February 10, 1989  
LD-89-017

Subject: License Amendment Request for R-2 Modifications

**HEMATITE NUCLEAR FUEL MANUFACTURING FACILITY**

**LICENSE AMENDMENT REQUEST**

Figure II.9-1

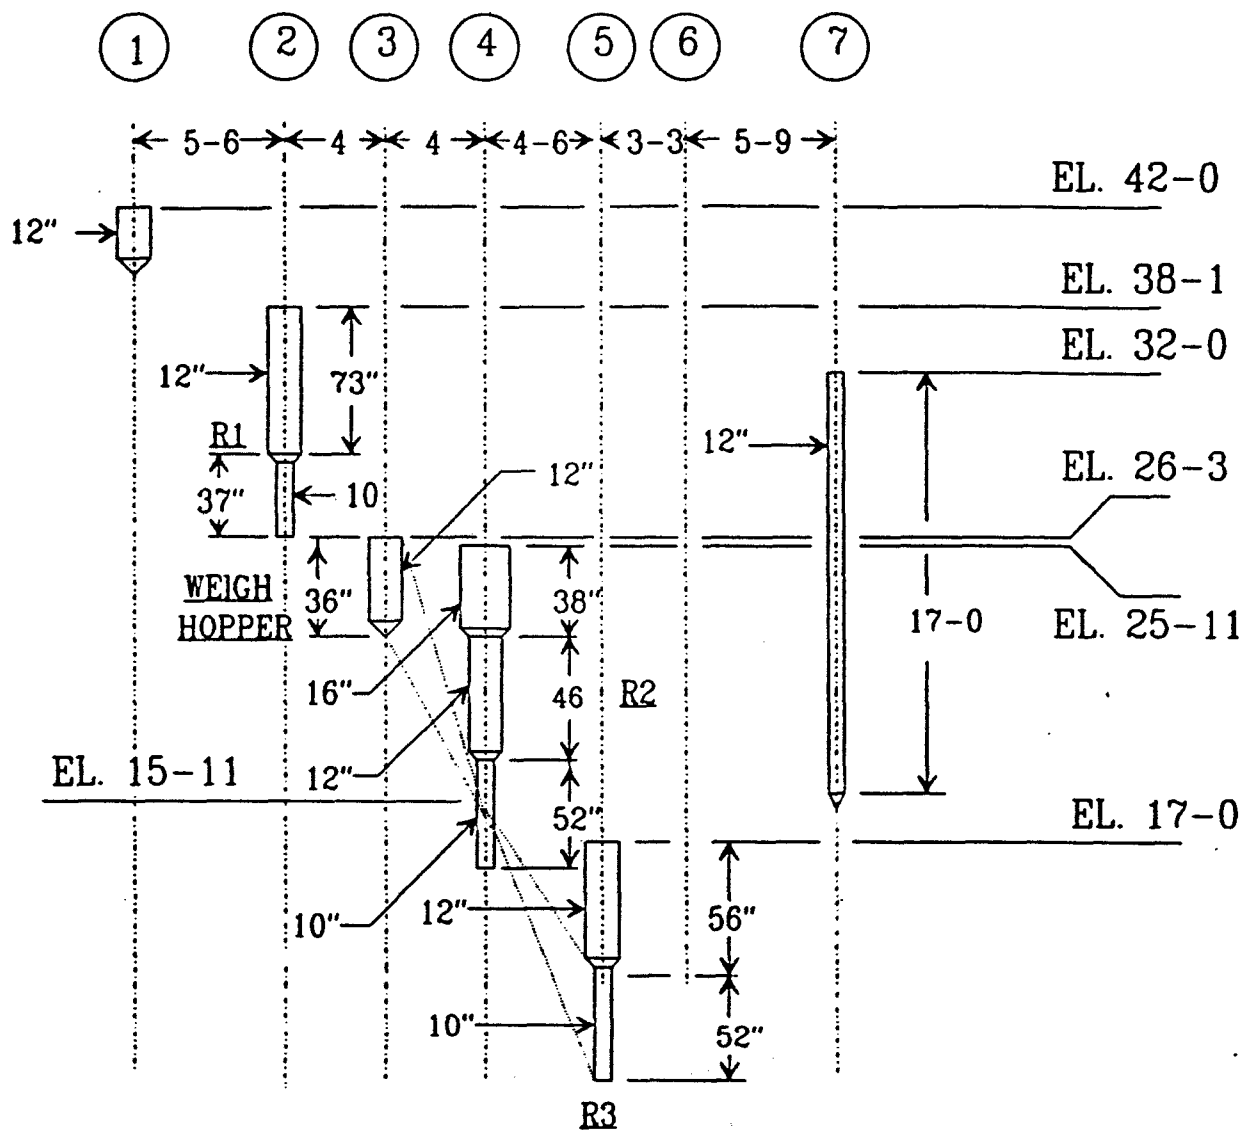
Vessel R-2 and it's furnace are shown in cross-section on Figure 9-2. For comparison, the upper end configuration of vessels R-1 and R-3 are shown in dotted lines. The elevation view of the UF<sub>6</sub>-UO<sub>2</sub> conversion reactor line is shown on Figure 9-1.

Figure II.9-2

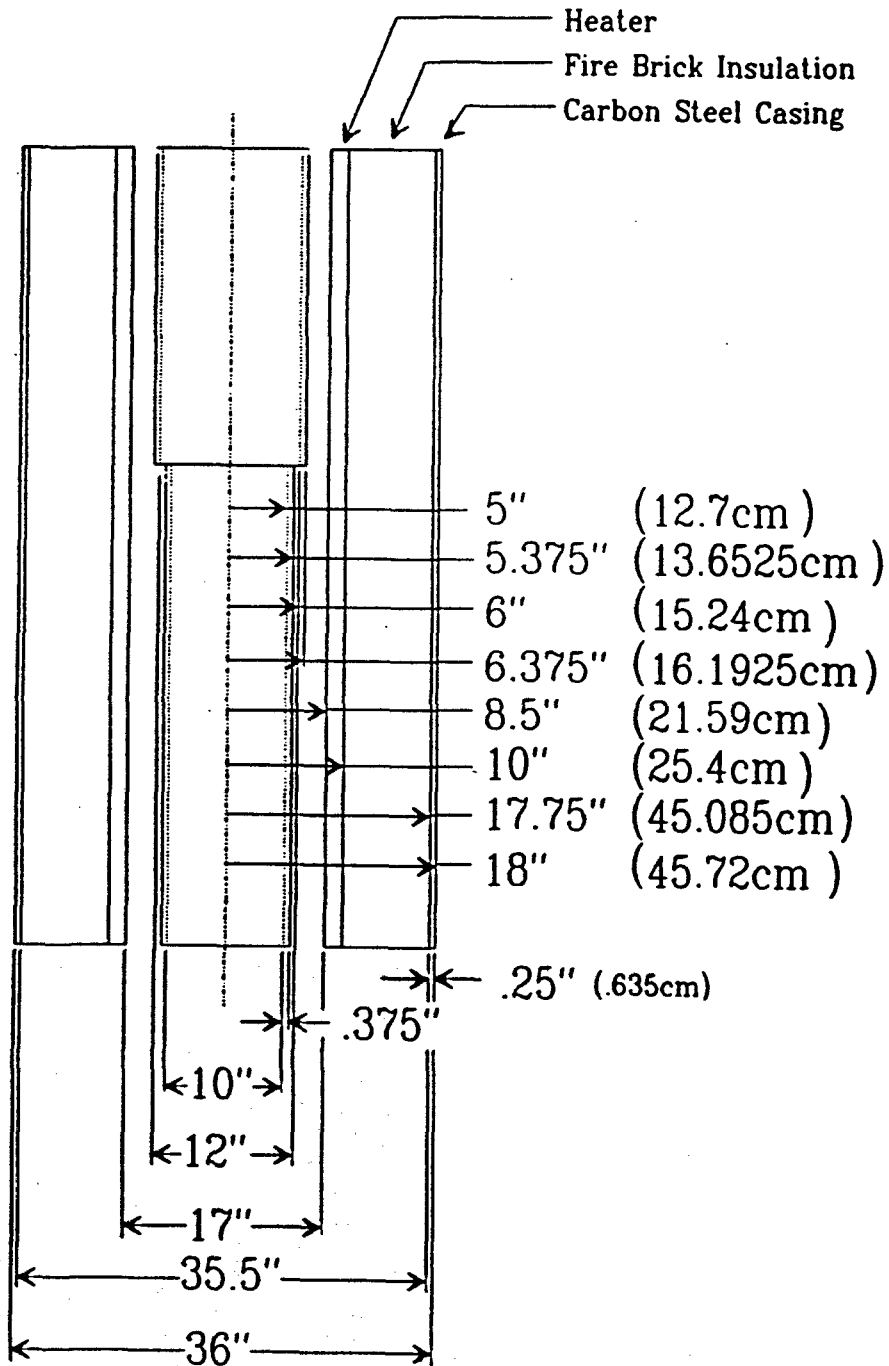
The lower sections (10" diameter and 12" diameter) are the same for all three vessels. Vessel R-2, however, has an additional 16" diameter section which increases the total height to 11'4".

- 1) Maximum enrichment 5.0%.
- 2) Under process design (normal) conditions, SNM is only in the 10" diameter lower section of the vessel.
- 3) Reflection as provided by furnace insulation; and vessel steel walls as shown in Figure II.9-2.

Nonetheless, a  $K_{\text{eff}}$  calculation has been made for an isolated R-3 reactor as shown in II.9-2. The  $K_{\text{eff}} = 0.9510 \pm .0055$ . (See page II.9-29)

- a) Reactors R-1 and R-2 were assumed to be filled in the 10" portion (i.e., no overfill) with dry  $\text{UO}_2$  at 2.5 g/cc density of powder and 5.0 w/o  $\text{U}^{235}$ . All structures consisting of .375" steel wall, 7.75" of 37.5 lbs/ft<sup>3</sup> firebrick insulation and .25" steel casing were included in the model. The conservative reactor details shown in Figure II.9-2 (page II.9-4) were used.

Figure II.9-3

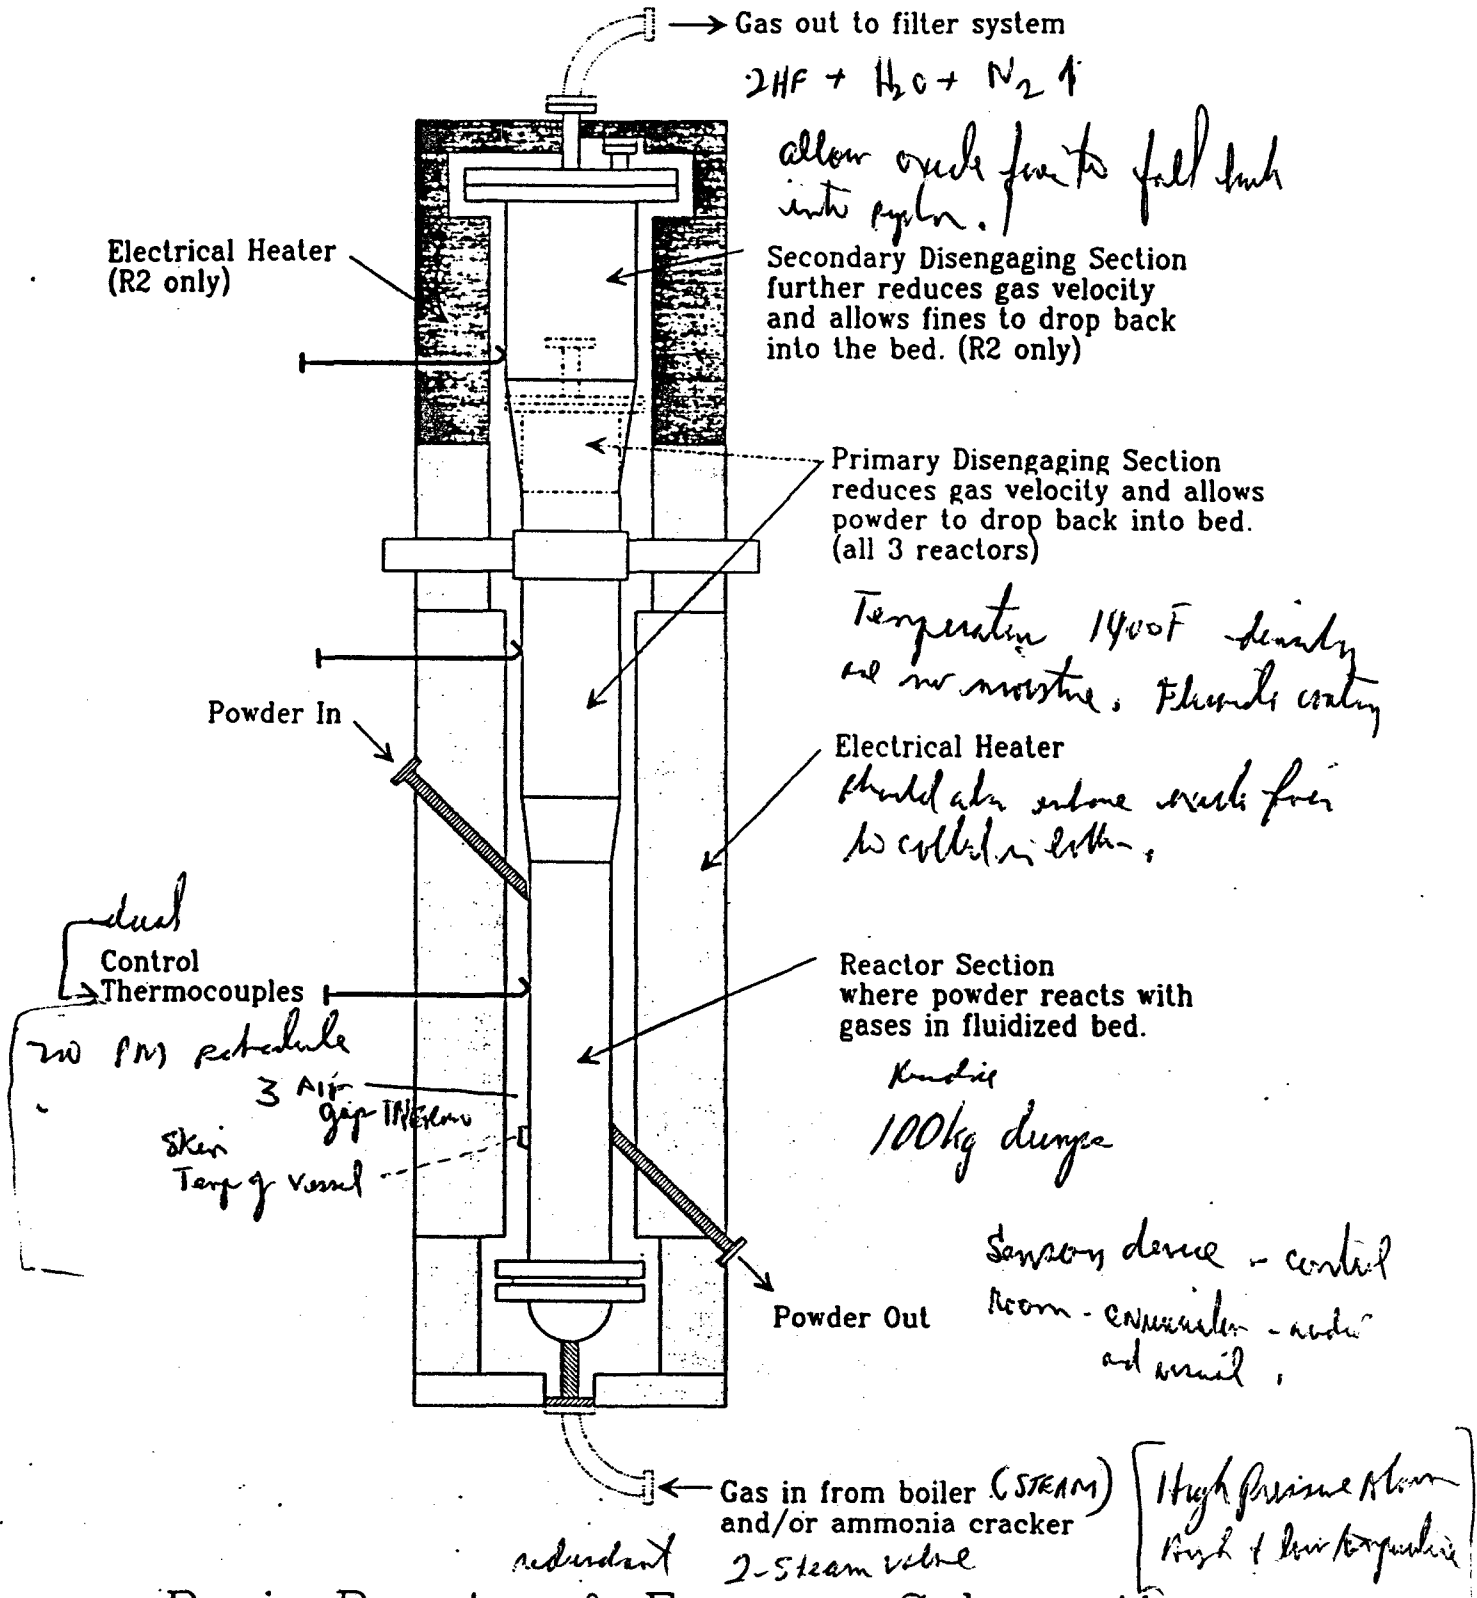
All three vessels are fitted with electrically heated furnaces. R-1 and R-3 have two independently controlled sections and R-2 has three independently controlled sections. All three reactors have low temperature alarm set points and R-2 has a second (redundant) low temperature alarm setpoint. In addition, the steam supply line to R-2 has two shut-off valves (one redundant) which are activated by the low temperature alarm setpoints from the R-2 controllers.
